REQUEST

Current Zoning: N1-A (single family residential)
Proposed Zoning: R-8MF(CD) (multi-family residential, conditional)

Approximately 42.46 acres located along the north side of Rocky River Road, west of Back Creek Road, and southeast of John Russell Road.

**STAFF
RECOMMENDATION**

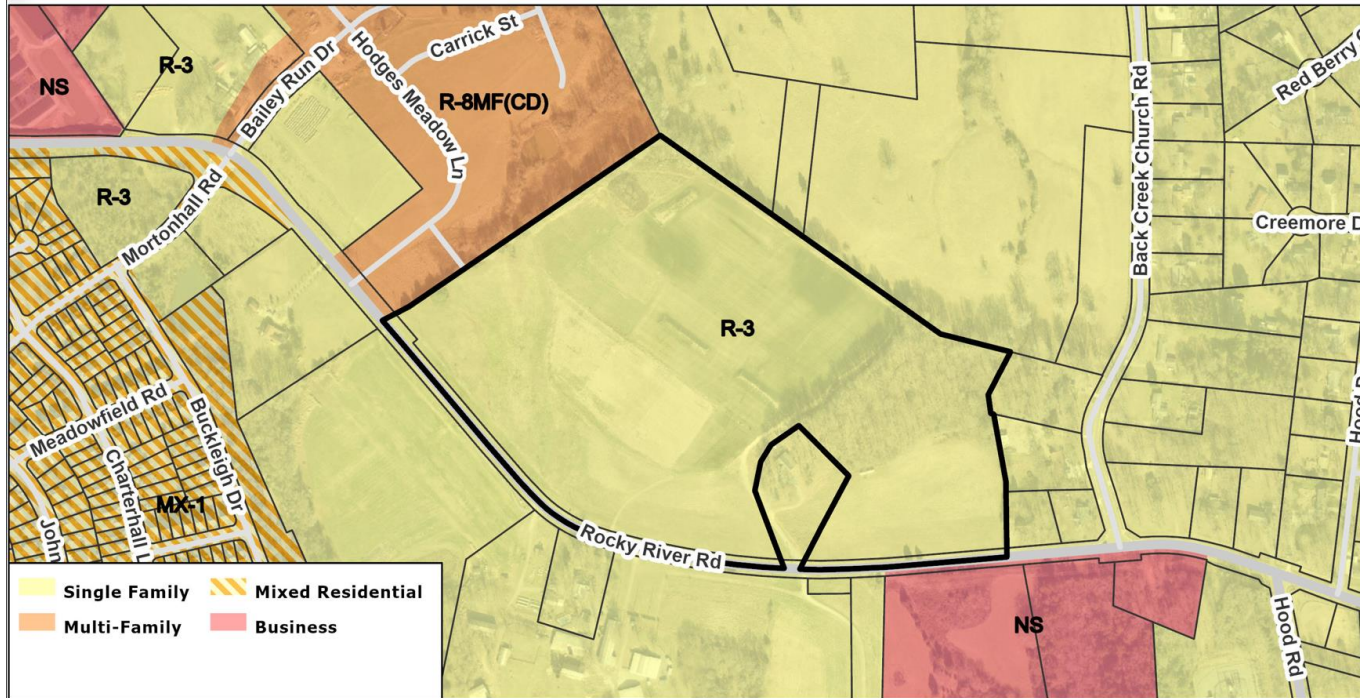
OUTSTANDING ISSUES

1. 4-foot Median is to be constructed on Rocky River Road. Label, dimension, and commit to proposed median. Addressed

2. The proposed berm shall be removed from the park dedication area. Addressed
3. The note needs to be revised to state that the 1.5 acres proposed park shall be dedicated and conveyed to Mecklenburg County for a future neighborhood park. Addressed
4. The site data table shows 15% tree save but there is not 15% show on the plans. Site is located in a wedge so a min of 15% of the overall site is required to be shown as tree save. Addressed

5. Specify if townhomes are to be "land for sale". Addressed
6. Add townhomes to proposed use. Addressed
7. Add to site data table: density allowed, density proposed, number of units allowed, number of units proposed. Addressed

8. Future Eastern Circumferential Road. Because of the road type setback should be discussed with staff.
9. Show and label required side and rear yards based on building orientation. This applies to the overall property boundaries not the sublots. Addressed

12. Show and label setbacks along all public streets. Addressed
13. Please clarify if this the minimum 50% open space required for R-8MF if so remove useable common. Addressed

14. Sublots cannot be in the buffers. Addressed
15. Buffers start at the setback. Addressed
16. If any buffers are being reduced it must be noted. Addressed

21. Development Data Table references the 50-foot Class C buffer, but not the 30-foot Class C buffer provided adjacent multi-family.
22. ~~New comment resulting from revised site plan dated 5/18/2023:~~ Previous site plans submitted state total 38.25 acres, while most recent plan states 42.46 acres. Please confirm which acreage is correct. Addressed

23. ~~New comment resulting from revised site plan dated 5/18/2023:~~ Add to Site Data Table—"15 ft. setback per Section 9.303(19)(f) of the zoning ordinance." Addressed
